DESCRIPTION AND SAFETY ANALYSIS  
OF PROPOSED CHANGE NPF-10/15-200

This is a request to revise Technical Specification (TS) 3/4.1.2.1, "Boration Systems - Flow Path - Shutdown," TS 3/4.1.2.2, "Boration System - Flow Paths - Operating," TS 3/4.1.2.6, "Boric Acid Makeup Pumps - Operating," TS 3/4.1.2.7, "Borated Water Source - Shutdown," TS 3/4.1.2.8, "Borated Water Source - Operating," TS 3/4.5.1, "Safety Injection Tanks," TS 3/4.5.4, "Refueling Water Storage Tank," and Associated Bases.

## DESCRIPTION OF PROPOSED CHANGE NPF-10/15-201 AND SAFETY ANALYSIS

This is a request to revise Technical Specification 3/4.2.4, "DNBR Margin", and 3/4.3.1, "Reactor Protective Instrumentation", and their associated bases.

FIGURE 3.2-2 DNBR OPERATING LIMIT BASED  
ON CORE PROTECTION CALCULATOR  
- COLSS OUT OF SERVICE  
- BOTH CEACS INOPERABLE

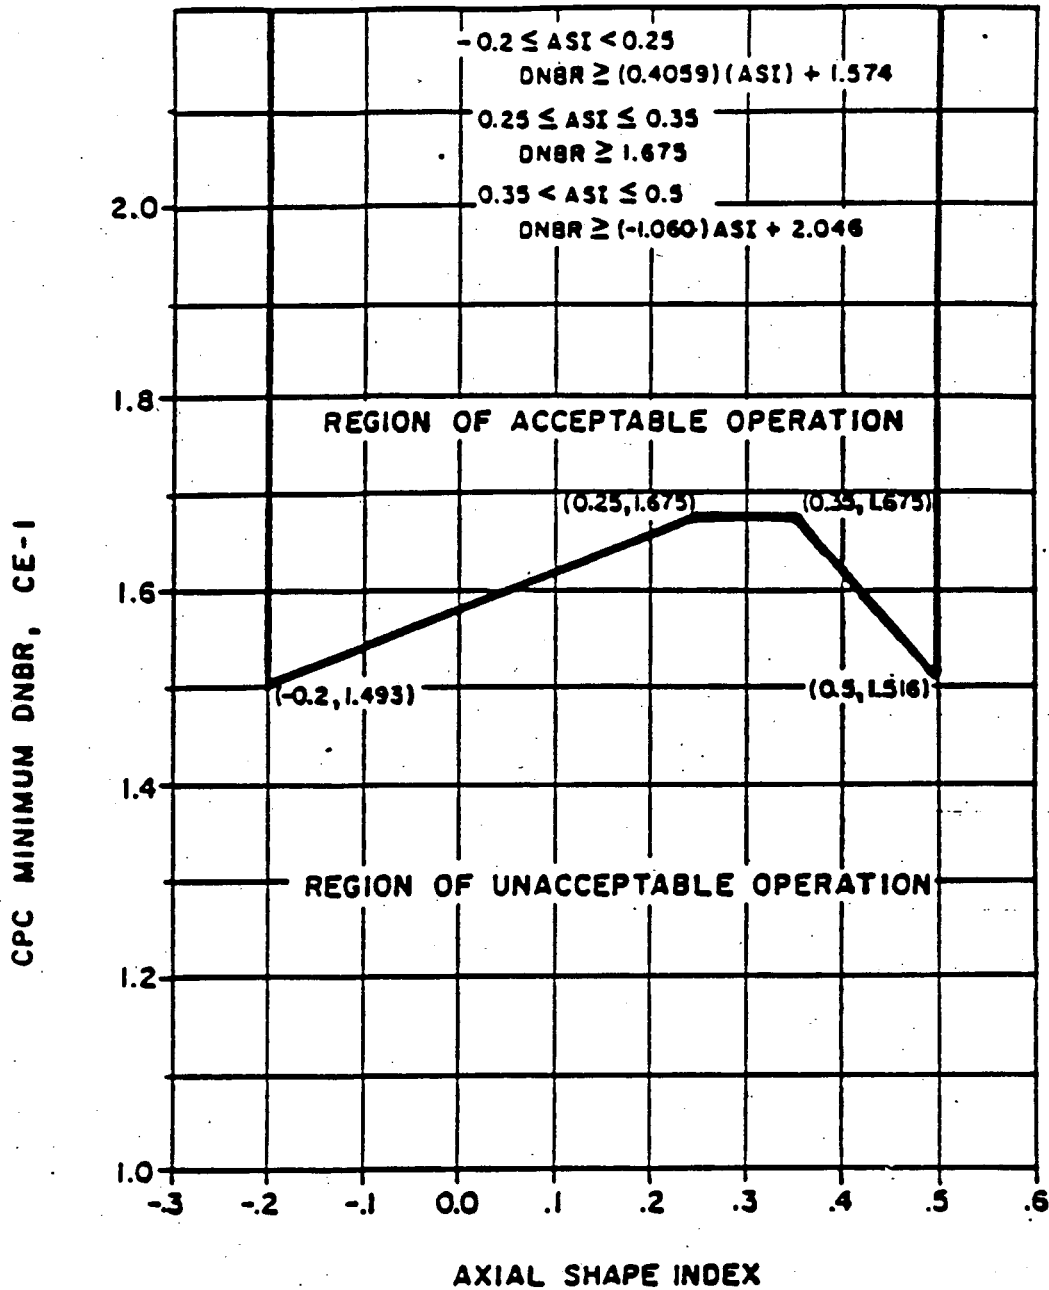
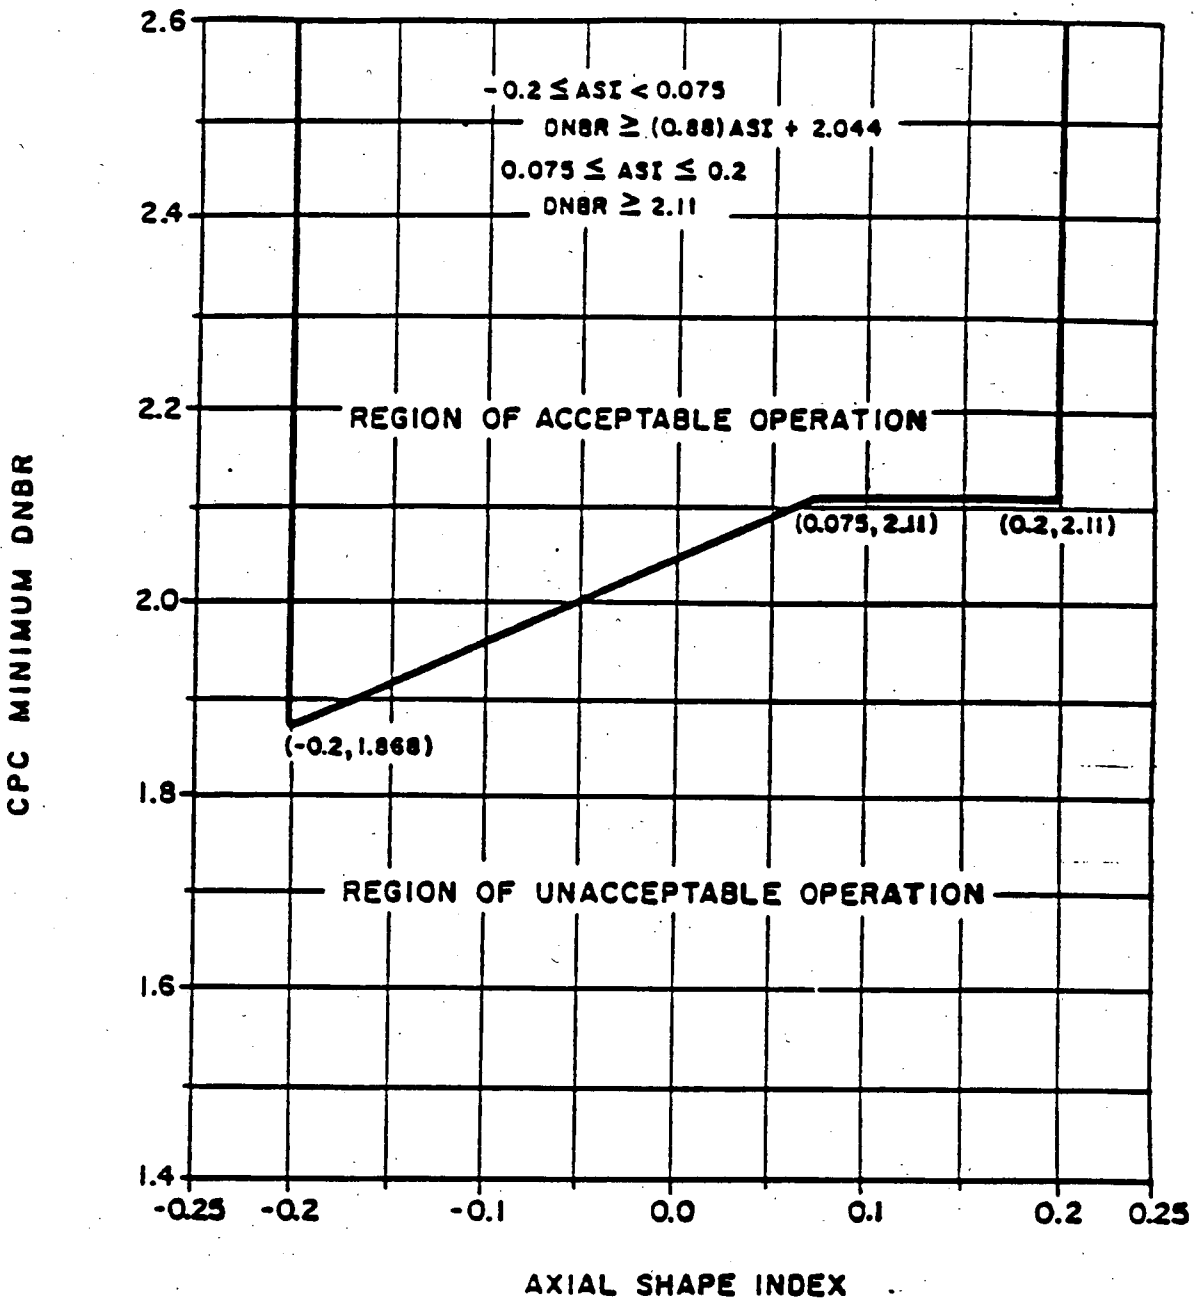
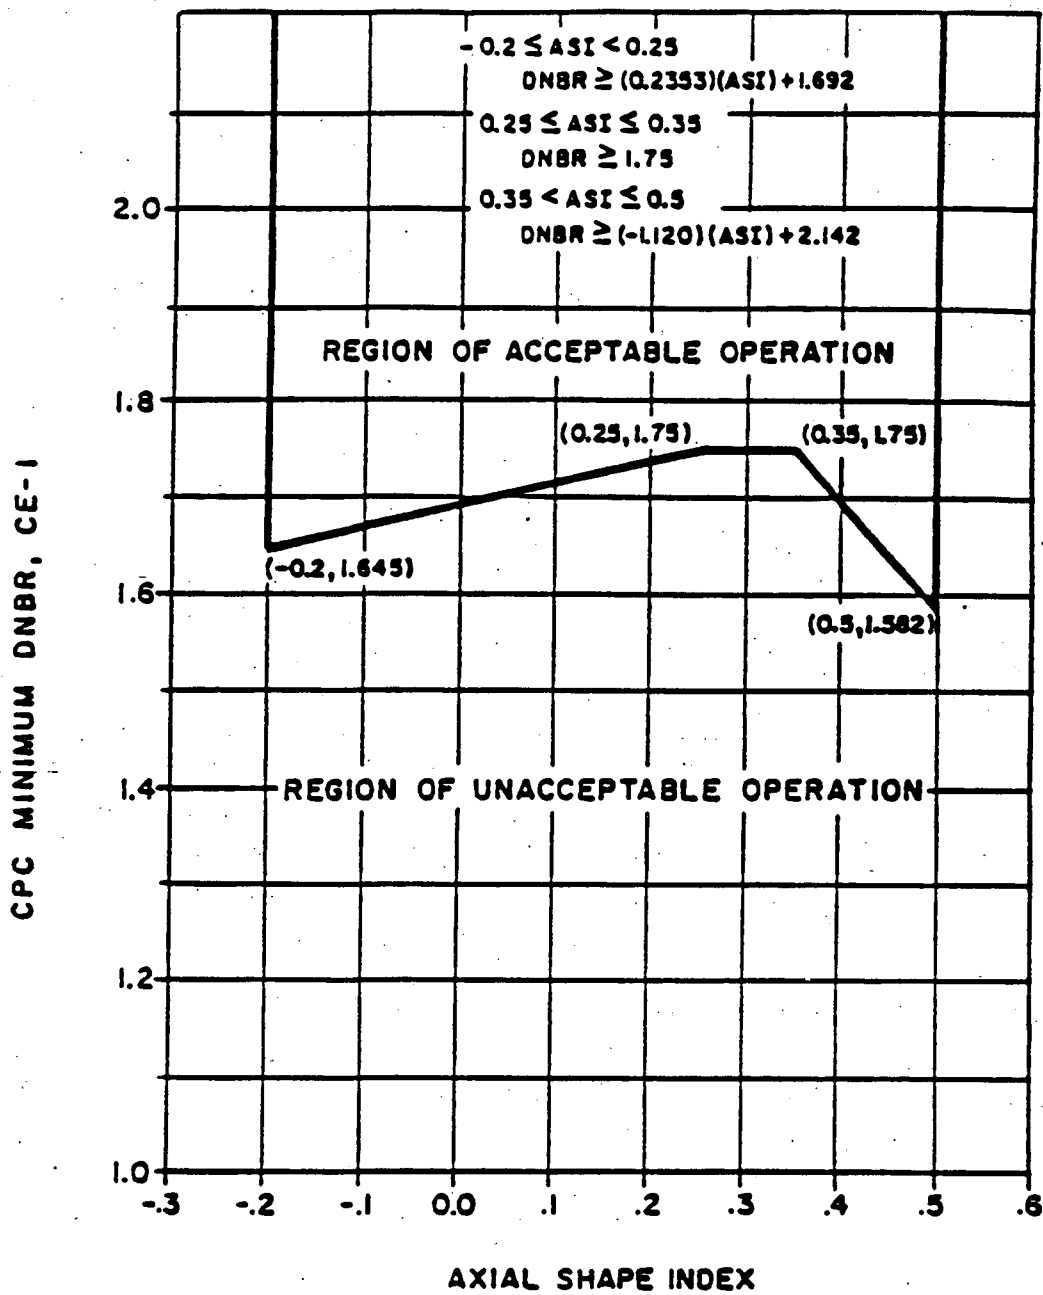
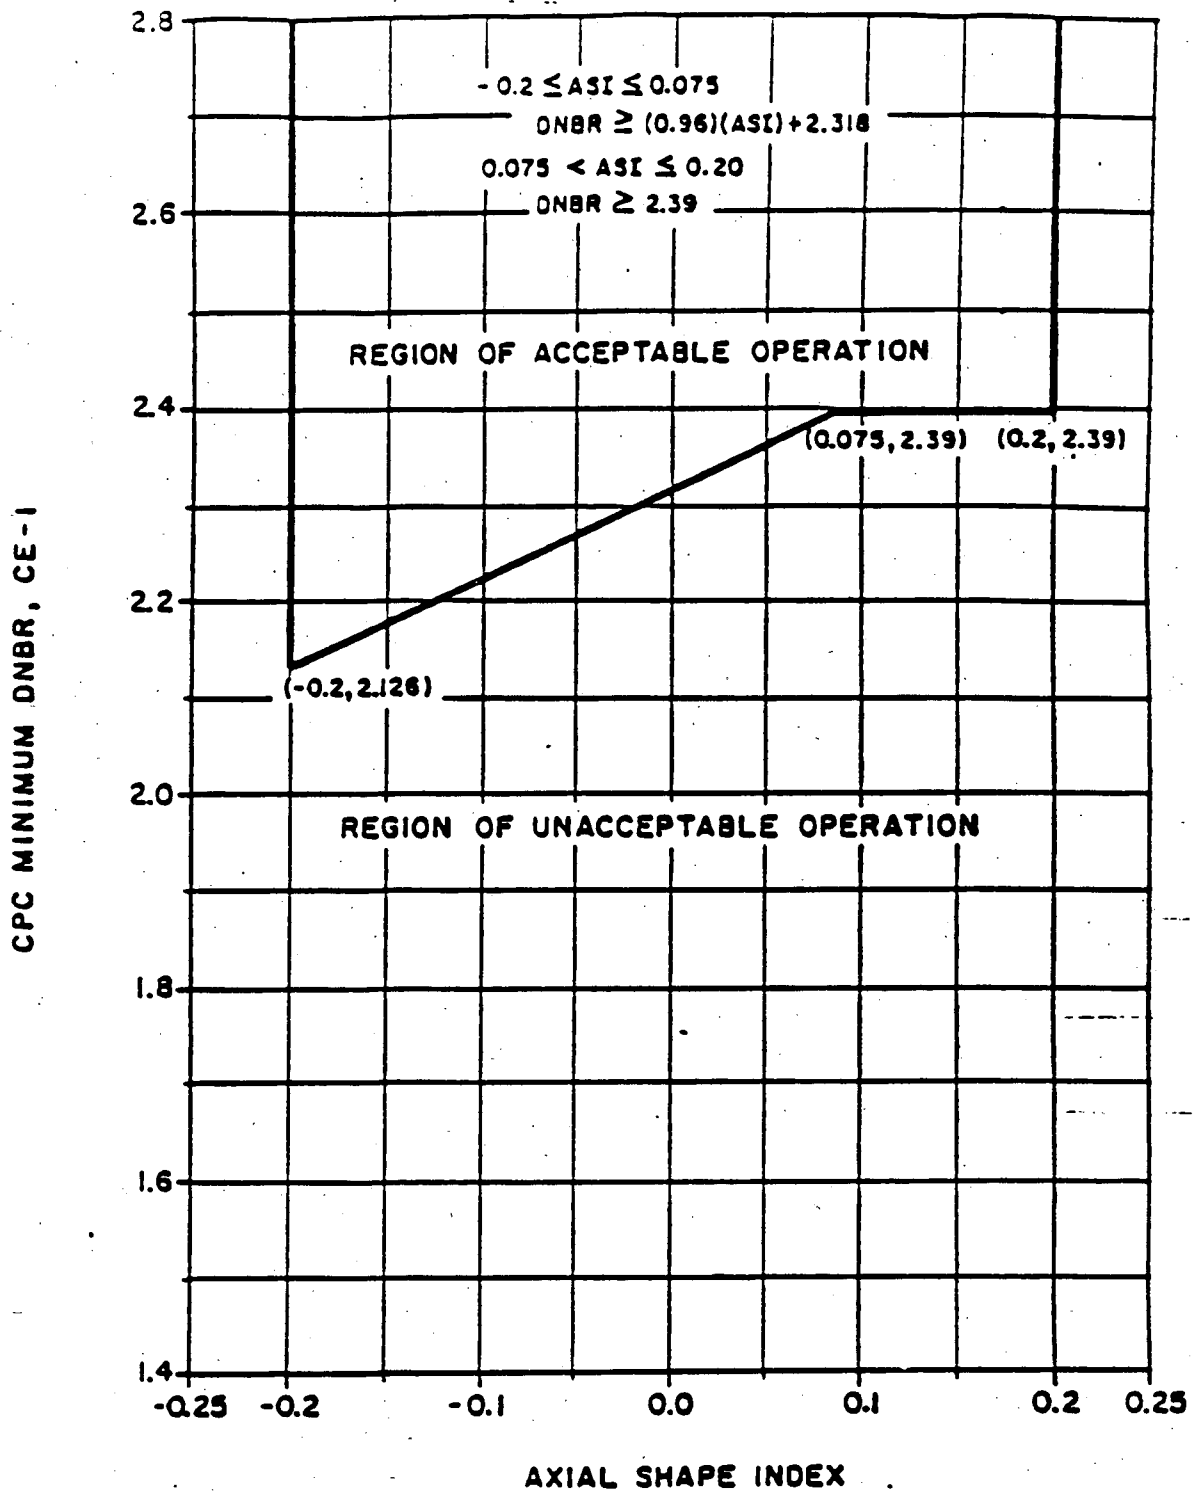
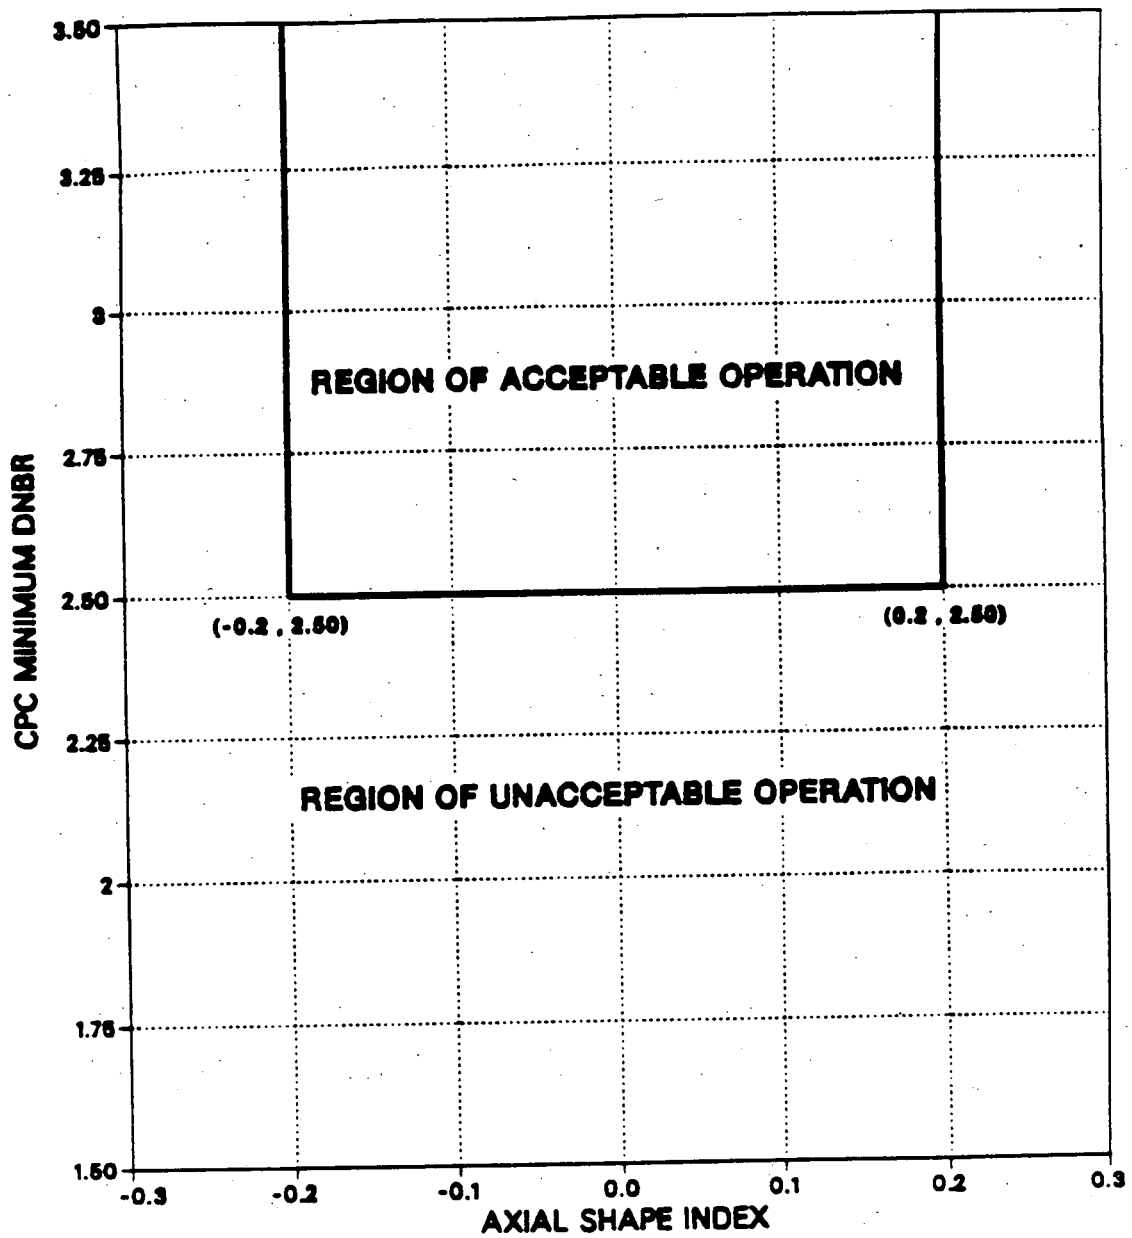
- a) The proposed change revises Figures 3.2-1, "DNBR Operating Limit Based on COLSS", Figure 3.2-2, "DNBR Margin Operating Limit Based on Core Protection Calculators (COLSS out of service, with power greater than or equal to 80% of rated thermal power)", and Figure 3.2-3, "DNBR Margin Operating Limit Based on Core Protection Calculators (COLSS out of service, with power less than 80% of rated thermal power)". Specifically, Figure 3.2-1 shows the minimum calculated Power Operating Limit (POL) based on DNBR for a given reactor power level. Provided that the COLSS POL is greater than that required by Figure 3.2-1 for a given reactor power, the plant is operating in the region of acceptable operation. The existing Figure 3.2-2 defines the required minimum DNBR margin for reactor operation at greater than or equal to 80% power. Figure 3.2-3 defines the required minimum DNBR margin for reactor operation at less than 80% power. The proposed change to Technical Specification 3.2.4 replaces the existing Limiting Condition for Operation (LCO) with four parts, 3.2.4.a through 3.2.4.d. 3.2.4.a and 3.2.4.b replace the existing Figure 3.2-1 with words to the same effect.

3.2.4.a and 3.2.4.b replace the existing Figures 3.2-1 with words to the same effect when COLSS is in service. Additionally, both new figures supplant the existing Figures 3.2-2 and 3.2-3 in compliance with 3.2.4.c and 3.2.4.d when COLSS is out of service. Thus, DNBR will be maintained by 3.2.4.a (or 3.2.4.c) when either one or both CEAC are operable and by 3.2.4.b (or 3.2.4.d) when neither CEAC is operable. Since the proposed change pertains to a revision of graphic representations in LCO with a set of plain administrative control statements easy for understanding and two consolidated figures for simplification, it is a change within the scope contemplated by Example (1).
